**AGENDA
PLANNING & ZONING COMMISSION
JOSHUA CITY HALL – COUNCIL CHAMBERS
101 SOUTH MAIN STREET, JOSHUA, TX 75058
NOVEMBER 2, 2020
6:30 PM**

RE: Conduct a public hearing and consider approving a Planned Development District and associated Detailed Site Plan on a 1.2348 acre tract of land located at the southwest corner of Joshua Station Blvd. and State Highway 174, and being located within the Joshua Station Overlay District with a Land Use Designation of CR, Corridor Retail for the purpose of constructing a mixed use center for restaurant, personal service, retail and medical offices.

Retail Shell Building
Joshua Station Addition
Lot 6
Broadway St (SH 174) at Joshua Station Blvd
Joshua, TX

Highland Meadows
29.713 Acres
47 Single Family Residential Lots
2 Open Space Lots

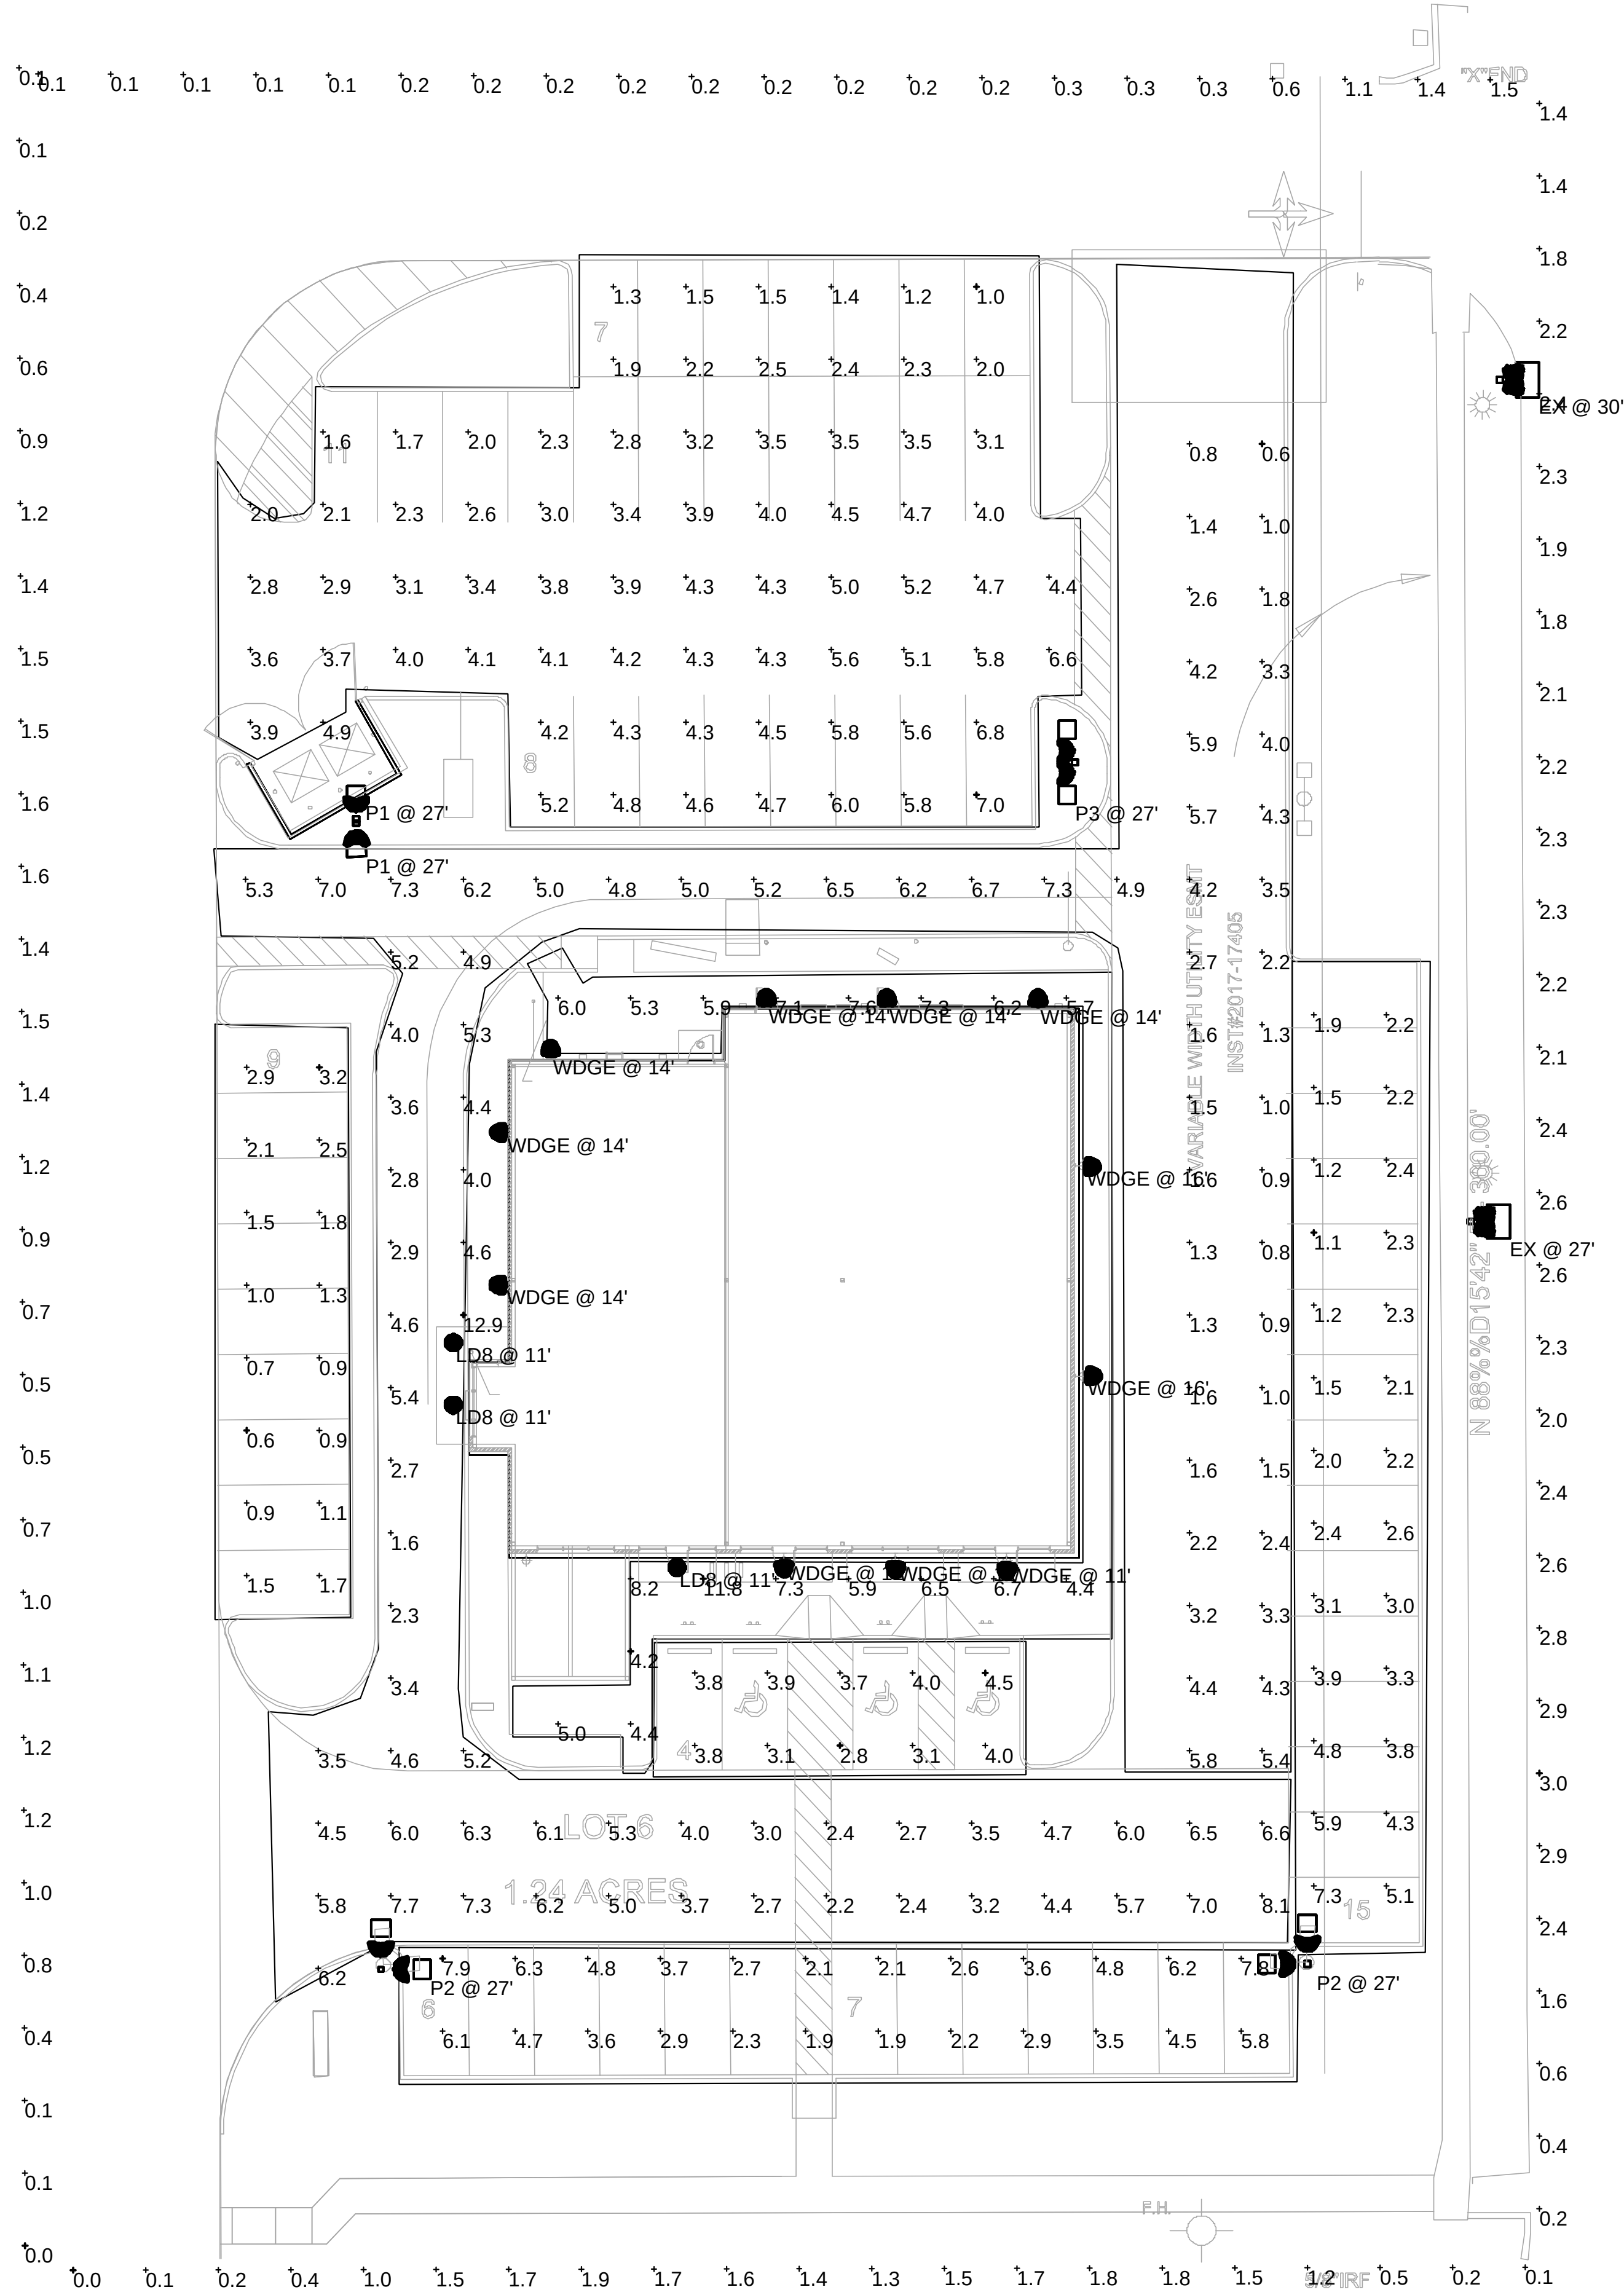
- a. Required street trees along Joshua Station Blvd shall be planted every 35 feet. A reduction of six (6) trees is requested in order for the proposed three (3) trees to align with those on the north side of Joshua Station Blvd.
- b. Required street trees along Broadway (SH 174) cannot be located within the area as set forth in the JSOD regulations due to location of existing utilities. Required street trees will be planted within the TXDOT ROW, pursuant to an executed lease agreement with the State. A copy of said executed lease agreement shall be furnished to the City prior to obtaining a Certificate of Occupancy. Landscaping shall be in accordance with Landscape Plan provided as part of this Detailed Site Plan.
 - a. In accordance with the provisions set forth in the Zoning Ordinance:

For this section's requirement, a variance is requested to allow the existing fence on the west property line that separates the multi-family development from Lot 6 to remain as shown on the Detailed Site Plan.

For this section's requirement, a variance is requested to reduce the number of trees required from seven (7) to five (5) as shown on the Detailed Site Plan due to extensive easements within the property boundary.

C-3.0

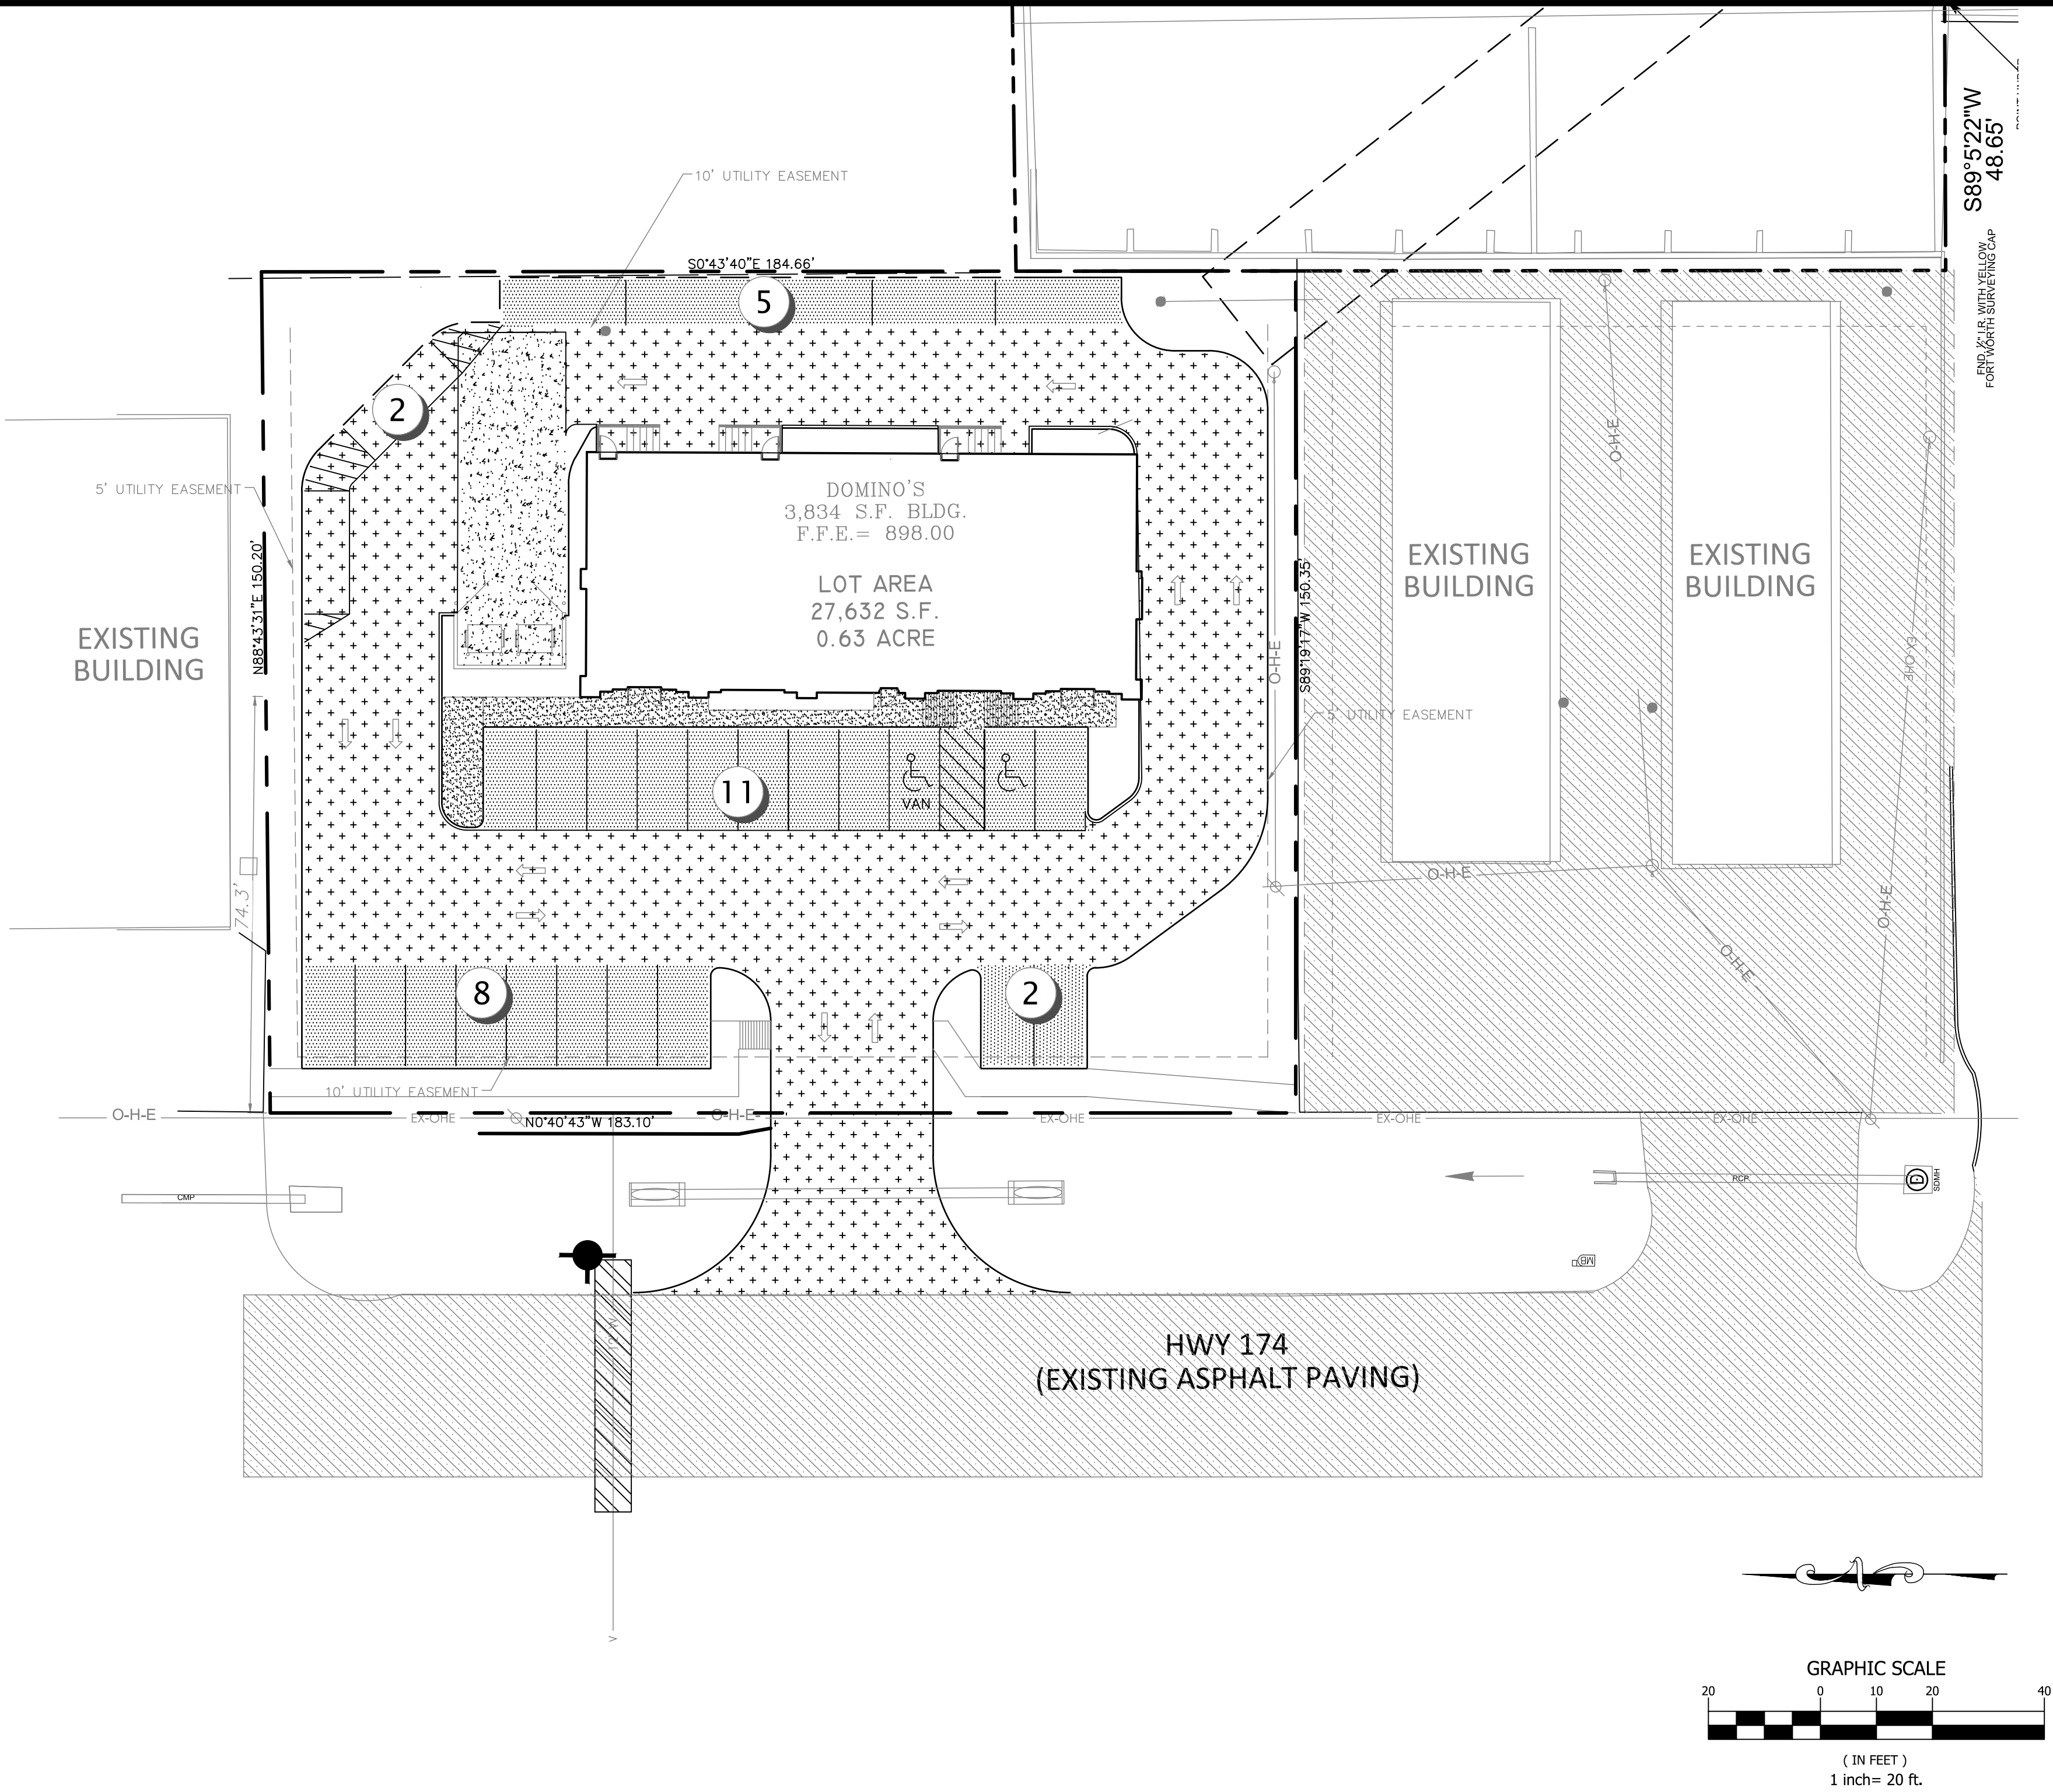
TRANSPORTATION: Initially, the City requested that the applicant provide a shared drive approach with the property to the south (existing storage buildings); however, the applicant submitted a variance request to Texas Department of Transportation (TXDOT) to allow them to not meet the state's Access Management guidelines. Prior to the TxDOT District Engineer signing off on this request, the State wanted to make sure the City was in agreement. The City Engineer and City Manager have discussed this and agree with approval of the variance request. Below is the explanation from the applicant:

- The required fire access lane will require the removal of the existing 48.5" American Elm at the southwest corner of the property.
 - This will require the planting of 17 – 3" caliper trees for tree mitigation (this does not include what's required for regular landscaping).

CROSS ACCESS EASEMENT:- The applicant proposes to dedicate a 24' wide cross-access easement to provide for future redevelopment north and south of the site.
